- DCR 016

ARKANSAS NUCLEAR ONE, UNIT 1

Amendment No. 104
License No. DPR-51

SUPPORTING AMENDMENT NO. 104 TO FACILITY OPERATING LICENSE NO. DPR-51

FIGURE 2.3-1

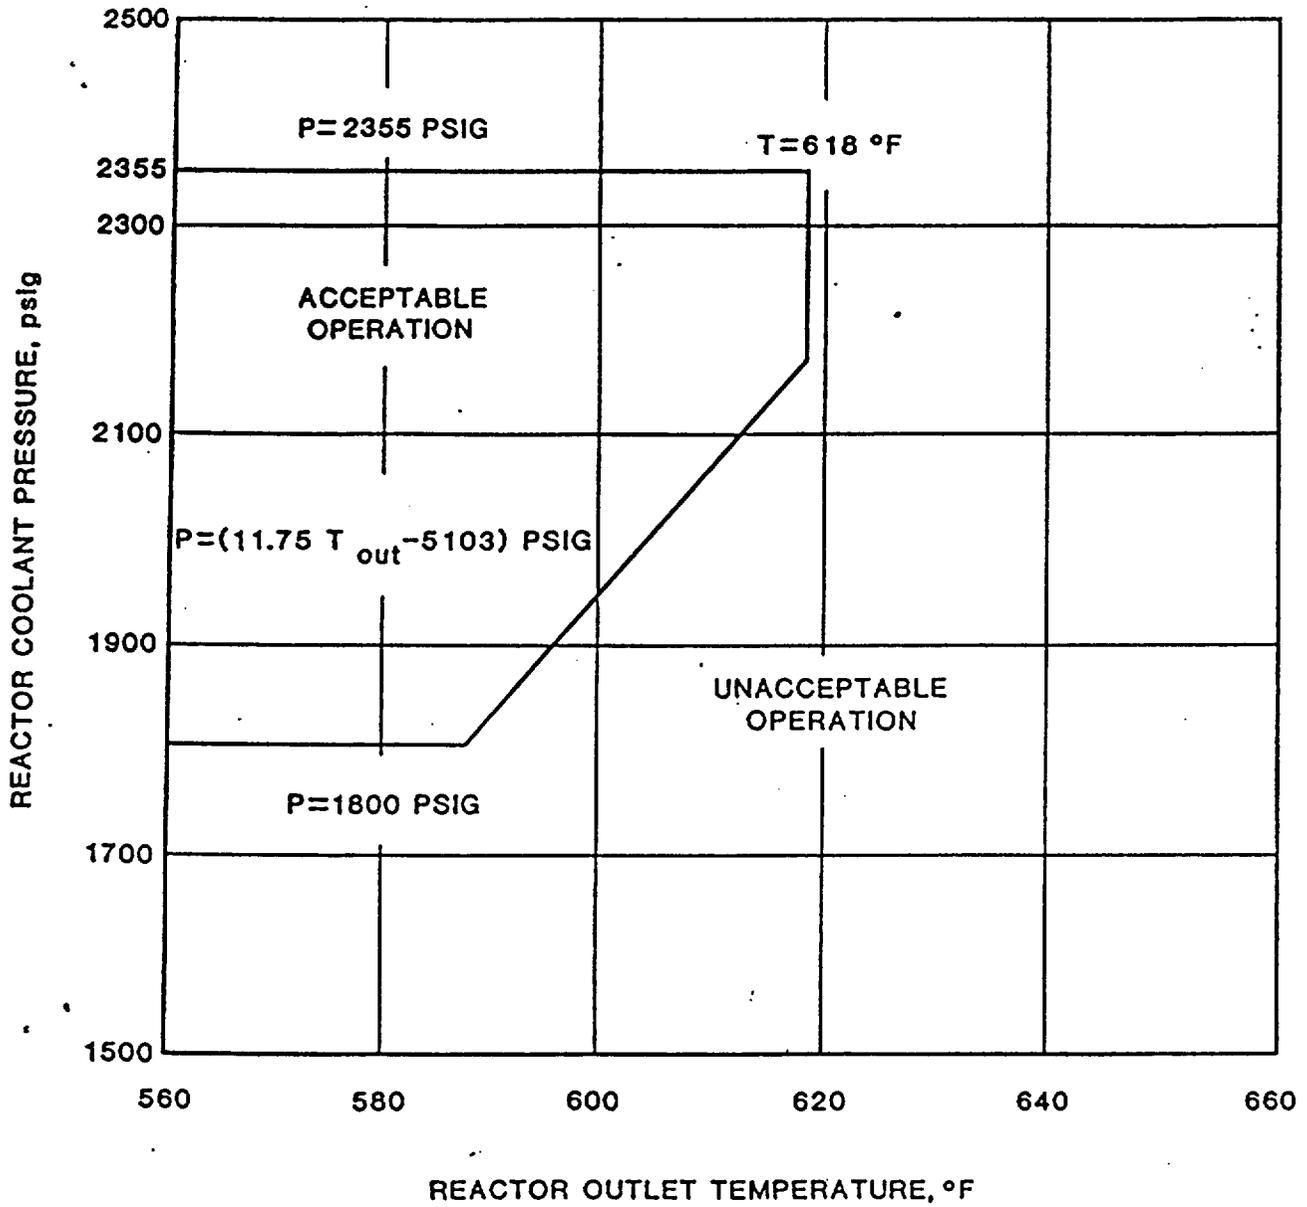
The amendment (1) increases the setpoint for reactor trip on high pressure from 2300 psig to 2355 psig, and (2) increases the anticipatory reactor trip on turbine trip arming threshold from 20% of full power to 45% of full power and (3) corrects several editorial errors.

During a startup accident from low power or a slow rod withdrawal from high power, the system high pressure trip is reached before the nuclear overpower trip setpoint. The trip setting limit shown in Figure 2.3-1 for high reactor coolant system pressure (2355 psig) has been established to maintain the system pressure below the safety limit (2750 psig) for any design transient.⁽²⁾

By letters dated July 18 and 31, 1986, the Arkansas Power and Light Company (AP&L or the licensee) requested amendments to the Technical Specifications (TSs) appended to Facility Operating License No. DPR-51 for Arkansas Nuclear One, Unit No. 1 (ANO-1). By letter dated October 17, 1986, the licensee provided clarifying information for the submittal dated July 31, 1986. The proposed amendments would (1) increase the setpoint for reactor trip on high pressure from 2300 psig to 2355 psig, (2) increase the anticipatory reactor trip (ART) on turbine trip arming threshold from 20% of full power to 45% of full power, and (3) correct several editorial errors. Specifically, the proposed amendments would change TS Figure 2.3-1, Table 2.3-1, 2.2 Bases, 2.3 Bases C, 3.5.1 Bases, TS 3.5.1.9.1, 3.5.1.9.2 and Table 3.5.1-1.

In regard to ANO-1, the licensee states in their supplemental response dated October 17, 1986, that the accidents analyzed in Chapter 14 of the Final Safety Analysis Report (FSAR) were based on the high pressure trip setpoint of 2355 psig (not the current setpoint of 2300 psig) and no credit for ART. The increase in the high pressure trip setpoint and the increase in arming threshold for ART will not increase the frequency of challenges to the main steam safety valves as compared to the initial plant design. Consequently, the accidents analyzed in the FSAR for ANO-1 bound the proposed TS changes.

We have reviewed the licensee's submittals and on the basis of the above, have determined that the proposed changes meet the applicable regulatory guidance and requirements and are, therefore, acceptable.
